La Marzocco Technical Bulletin # 132

Vulcano Swift new power board.

March 15, 2017

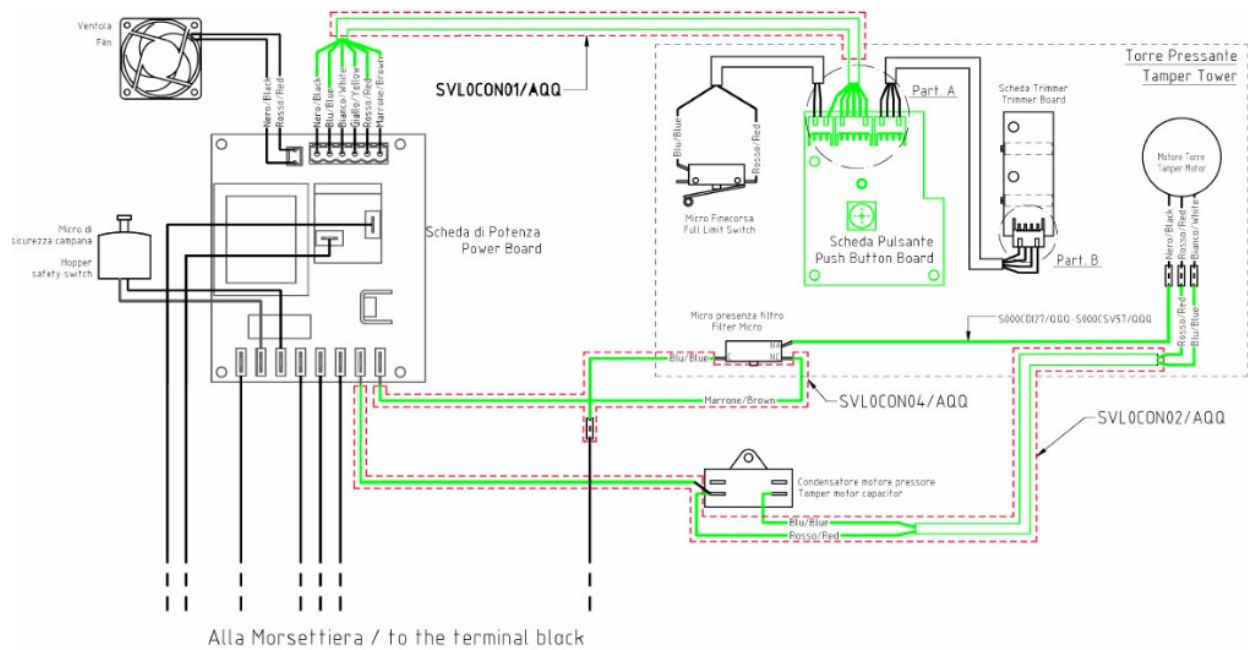
The Vulcano Swift power board has been modified and now has different connections. Only the new version of the power board is available as a replacement part. In the event the power board needs to be replaced it will be necessary to pay attention to the serial number to confirm if a retrofit kit is necessary.

The retrofit kit includes a new power board, new push-button board and all necessary cables. Everything in green in the following diagram is included in the retrofit kit and will need to be replaced:

All Vulcano Swift starting from serial number 1349118 have the new board. The retrofit kit is not necessary. If the serial number is 1349117 or lower, the retrofit kit is required.

M.1.039 Vulcano Retrofit board kit, 120V (SN up to 1349117)

M.1.291 Vulcano, Swift Power Board
